May 18, 2023 Standards Committee Meeting

RE: Agenda for the May 18, 2023 Standards Committee Meeting

PROPOSAL TO STANDARDS COMMITTEE

PROPOSED FIGURE TO BE SHOWN IN GENERAL INSTRUCTIONS TO FIELD EMPLOYEES (GIFE)

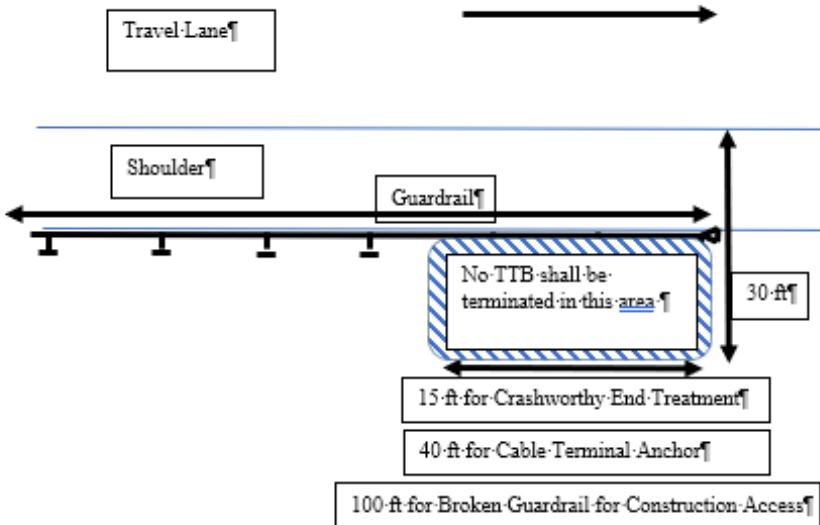
Where temporary traffic barrier is terminated behind guardrail within 30 ft from the edge of the adjacent travel lane, the ends of the TTB shall not be within 10 feet of the face of guardrail, and the TTB shall overlap:

- → a crashworthy guardrail end treatment by more than 15 ft,
- → a guardrail cable terminal anchor by more than 40 ft, or
- → a run of guardrail that has been broken for construction access by more than 100 ft.

No portion of the temporary traffic barrier shall be within 10 ft behind the face of guardrail.
